ADDENDUM NO. 2

March 1, 2022

**TIMOTHY BALL ELEMENTARY SCHOOL ADDITIONS, RENOVATIONS,
AND RELATED WORK
Crown Point, IN 46307**

This Addendum forms a part of and modifies the Bidding Requirements, Contract Forms, Contract Conditions, the Specifications, and the Drawings dated February 7, 2022 by Gibraltar Design. Acknowledge receipt of the Addendum in the space provided on the Bid Form. Failure to do so may subject the Bidder to disqualification.

A-411

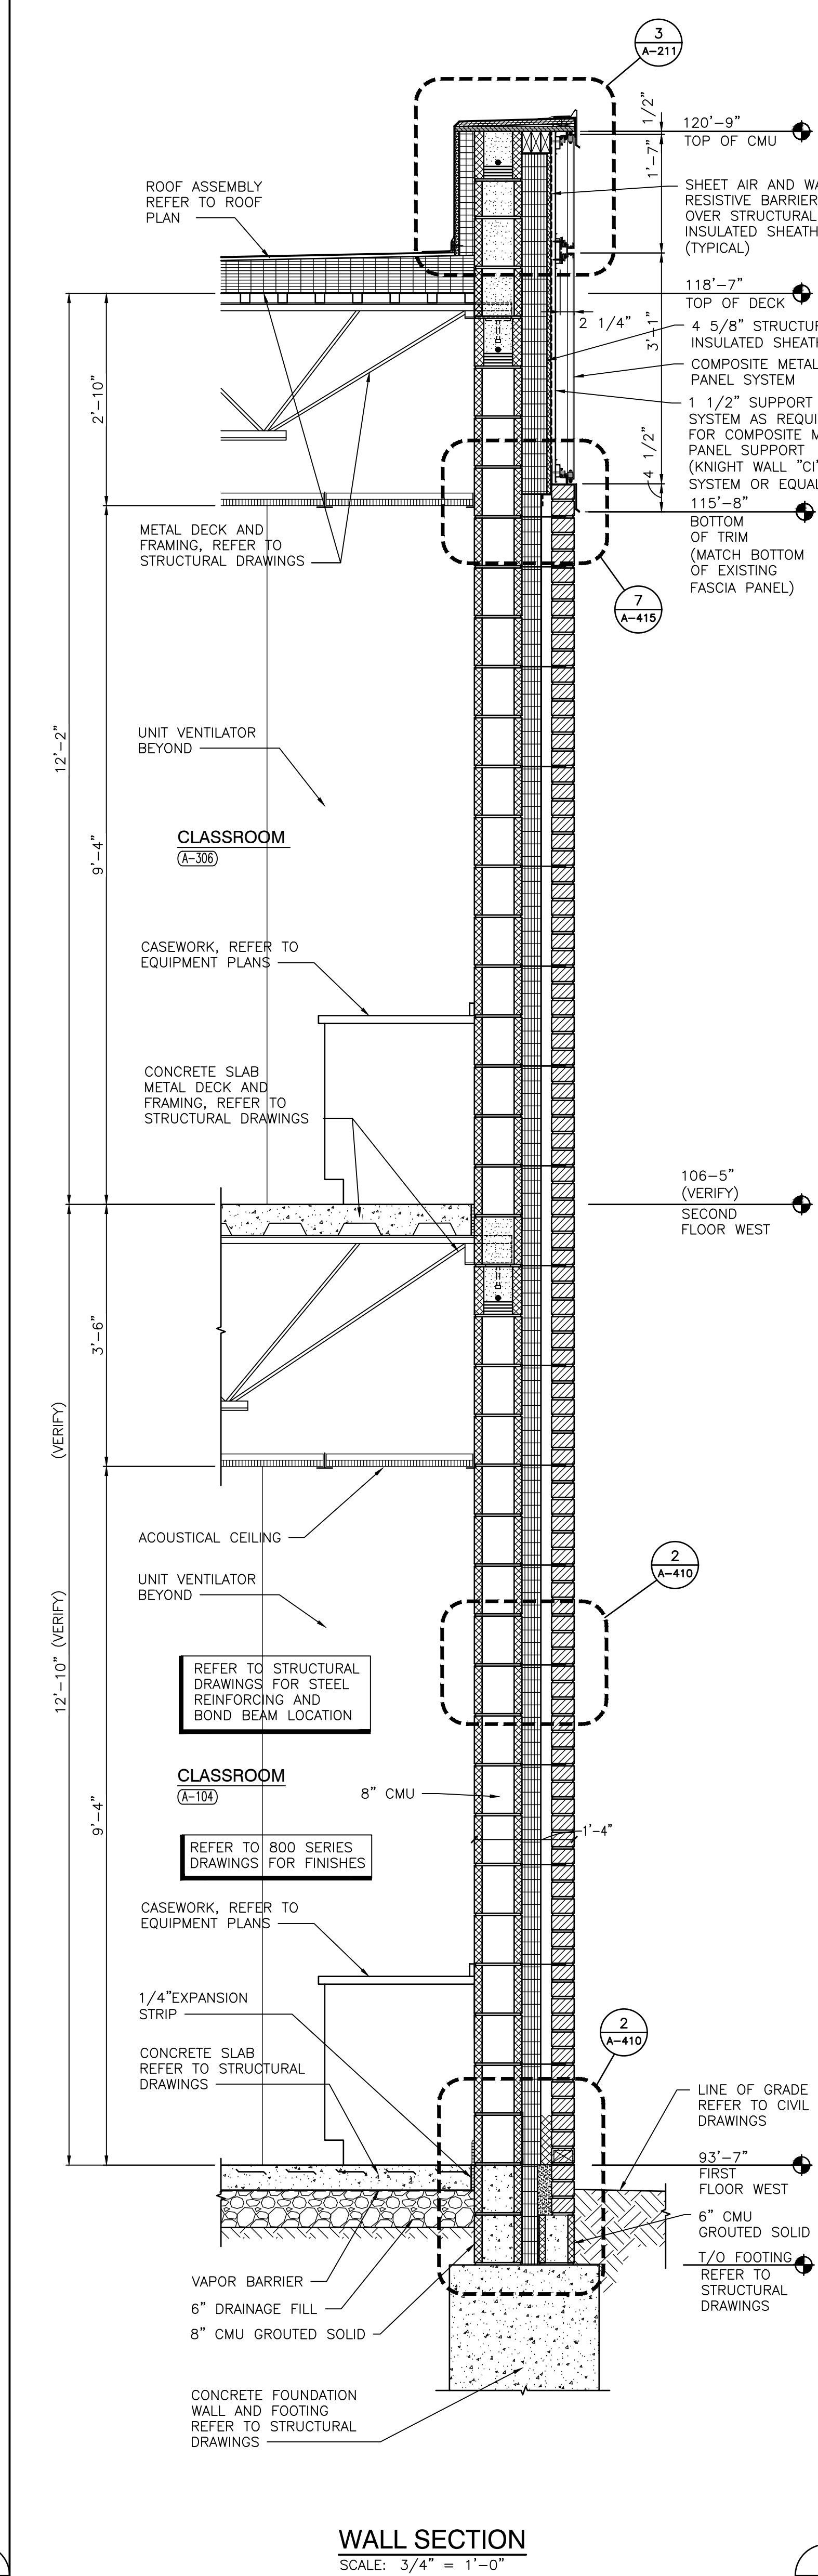
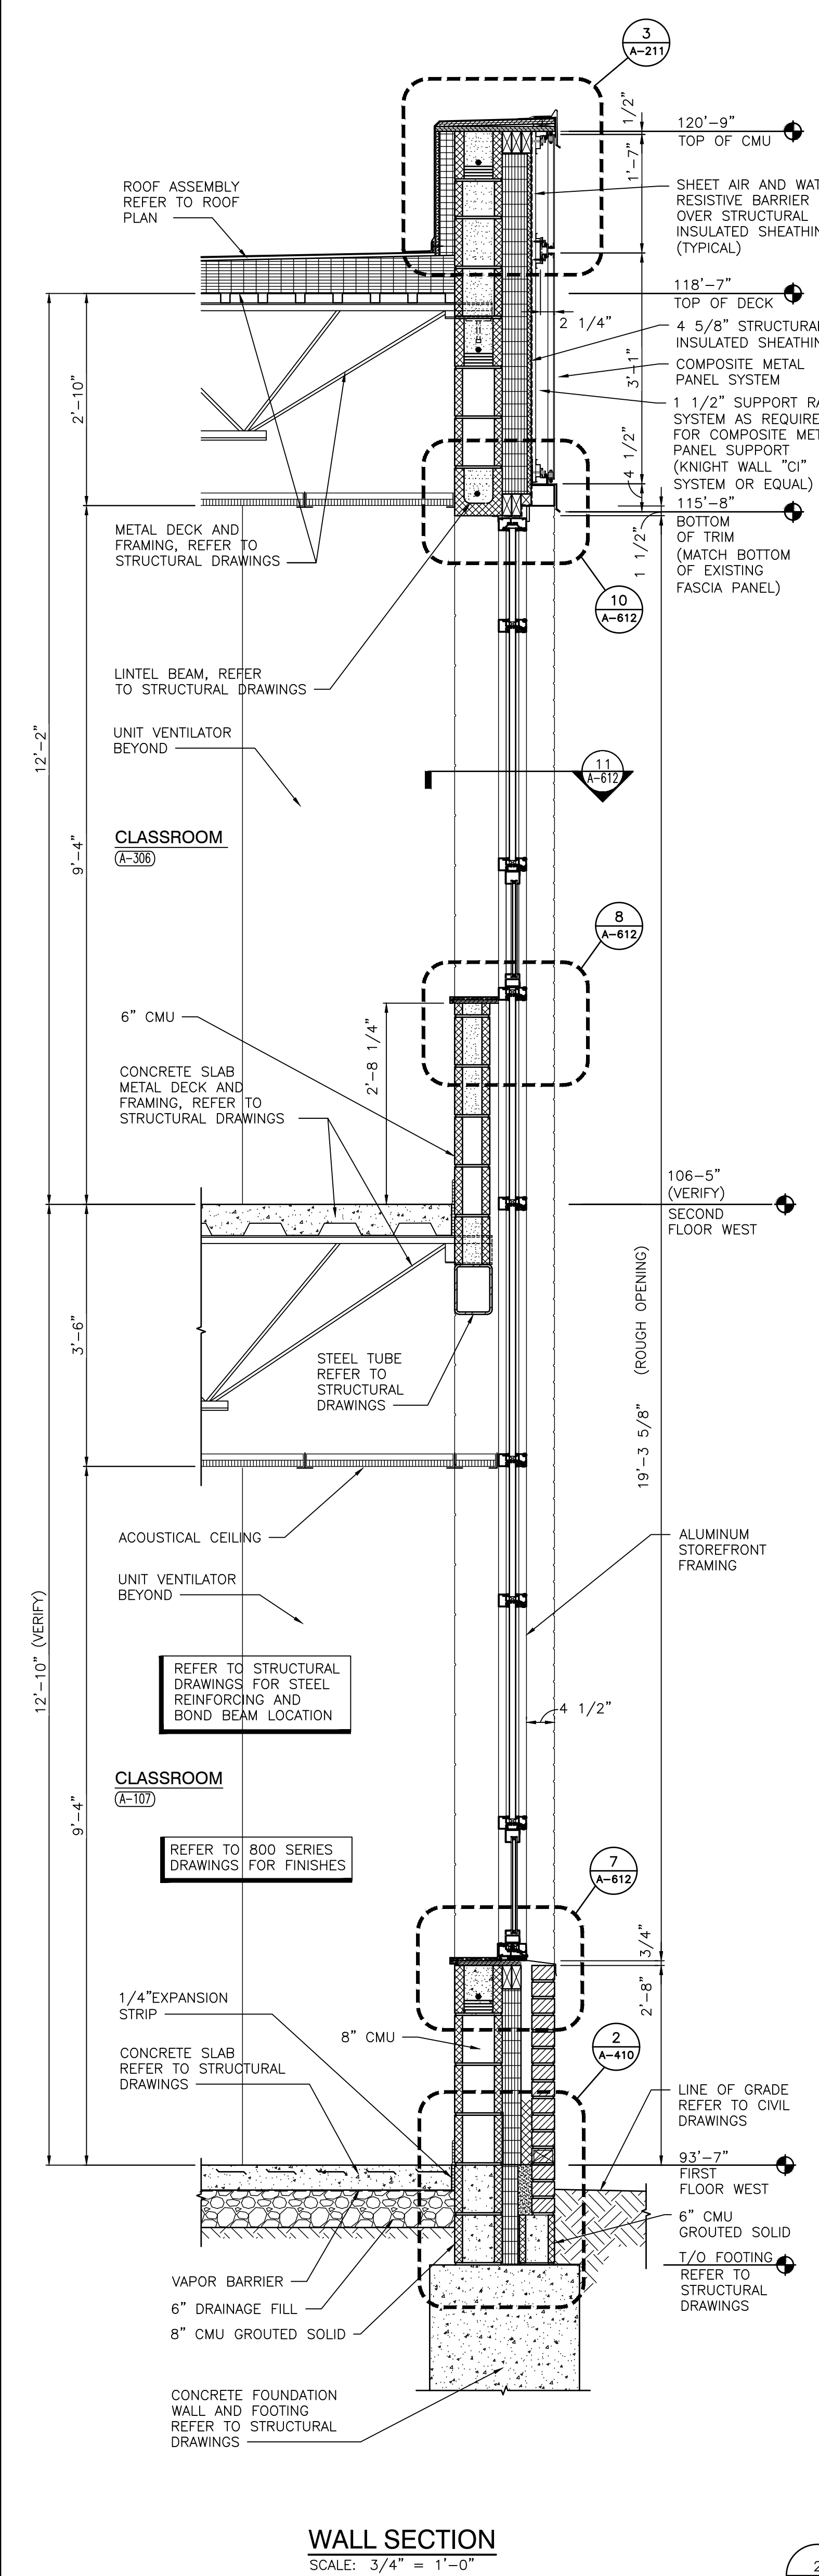
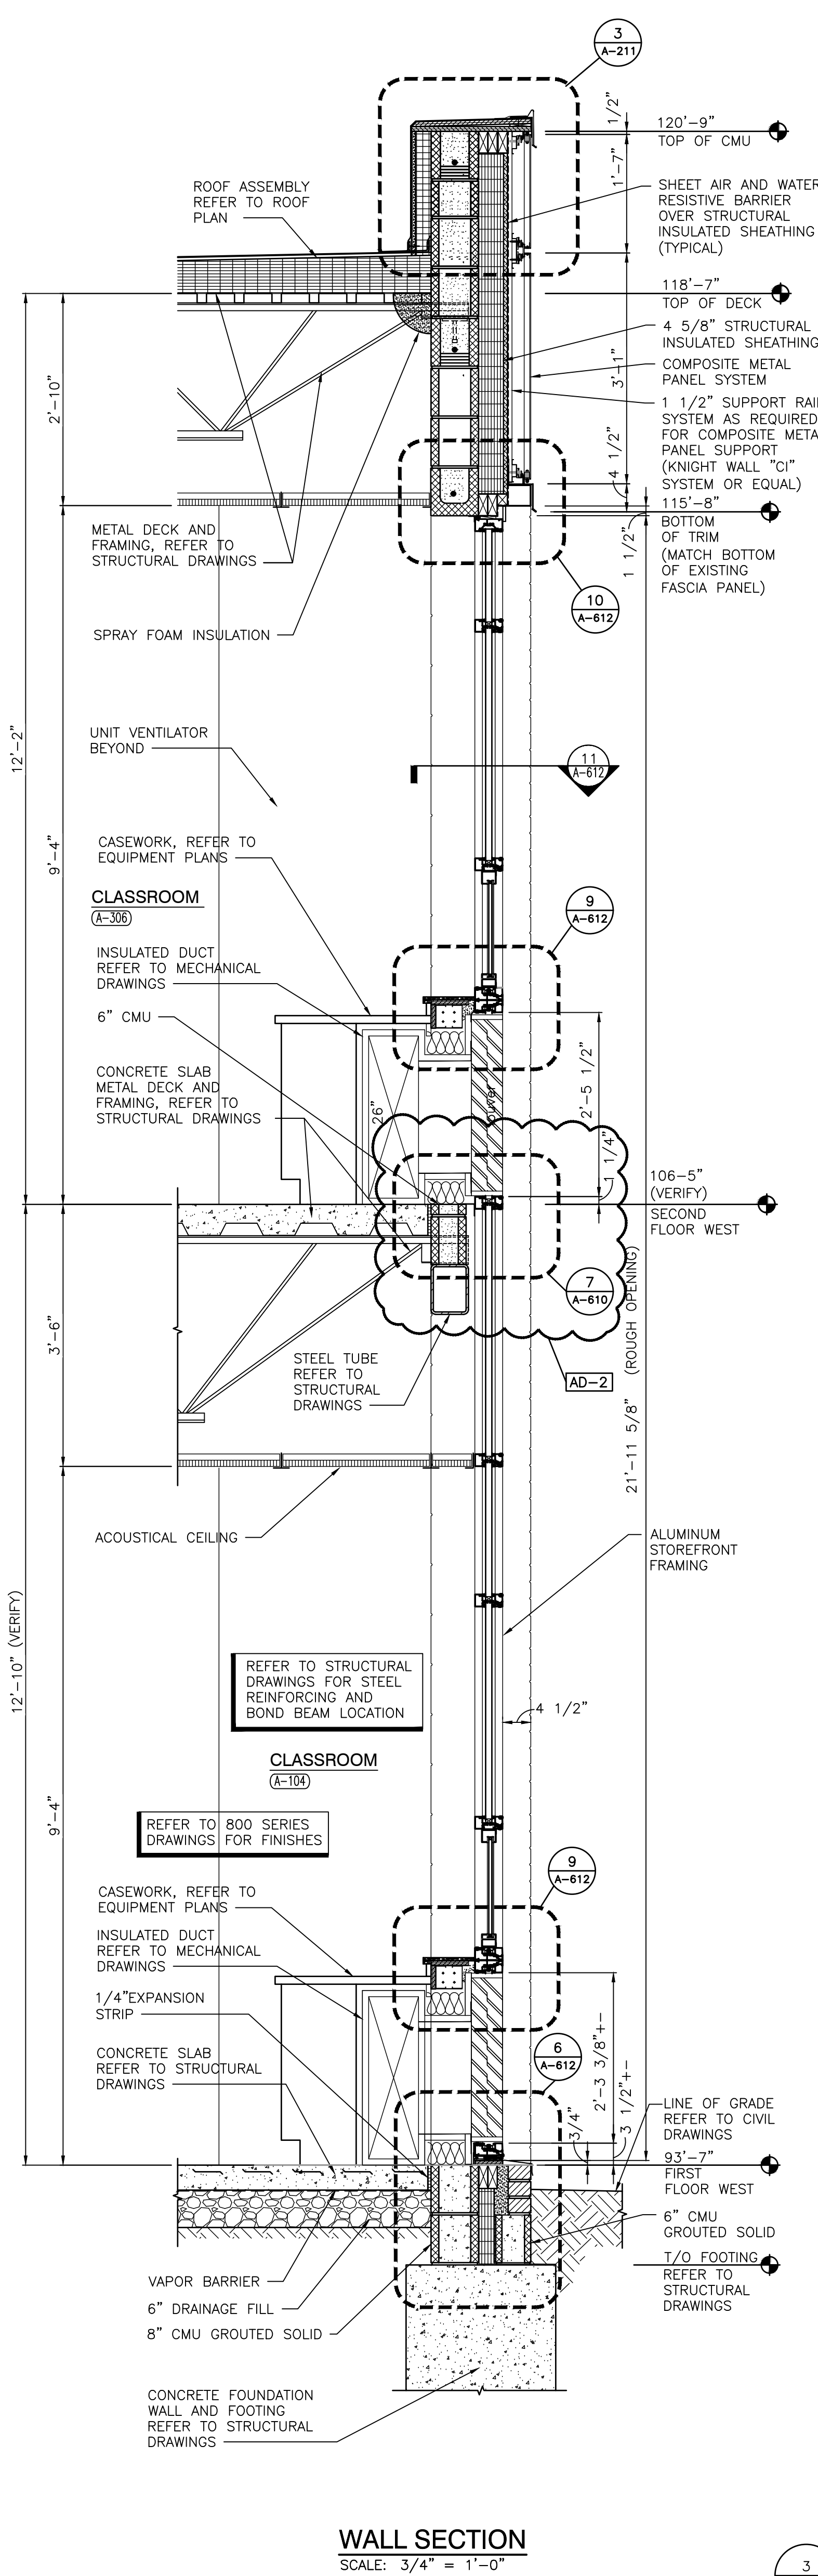
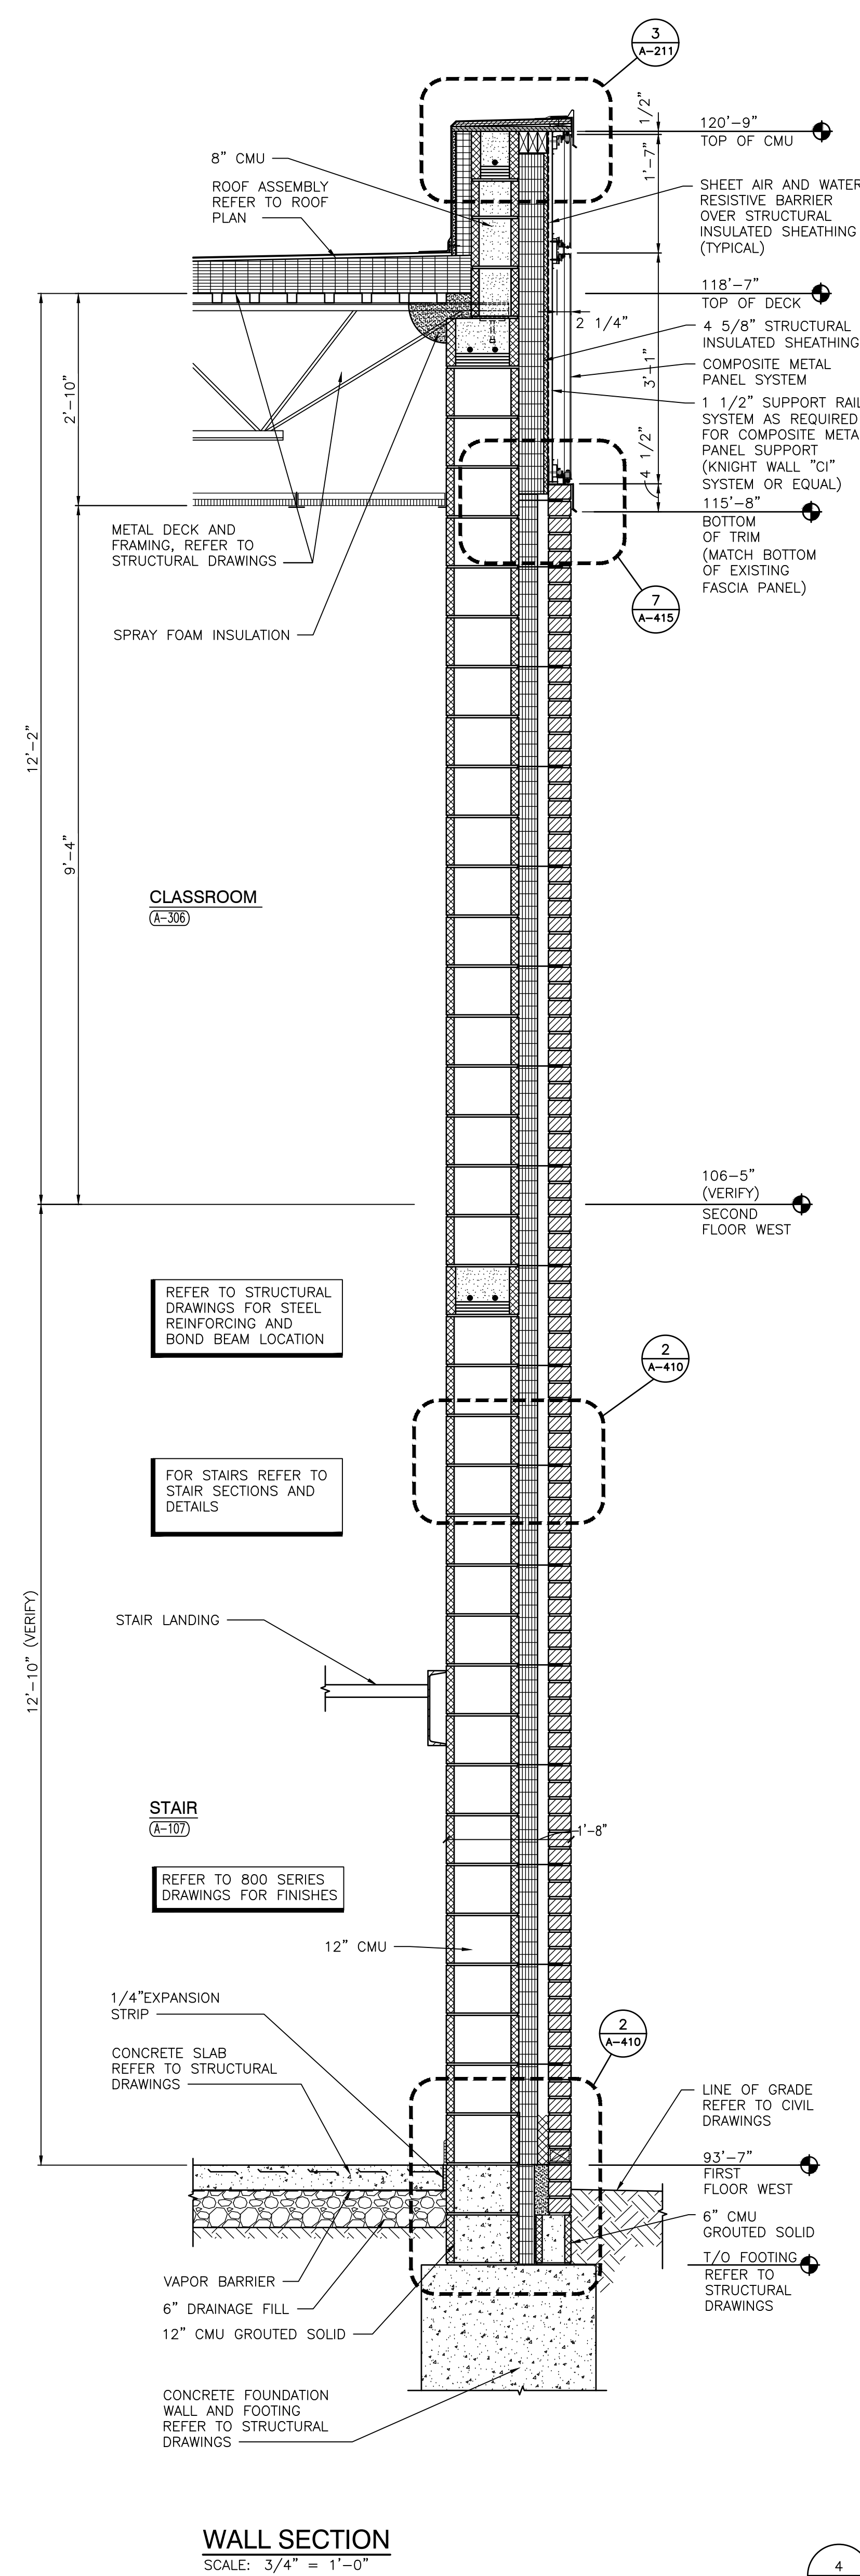
12. Sheet A-411

1. Add reference bubble 9/A-612.
2. Refer to Section Drawing for clouded dimension revisions in multiple locations.
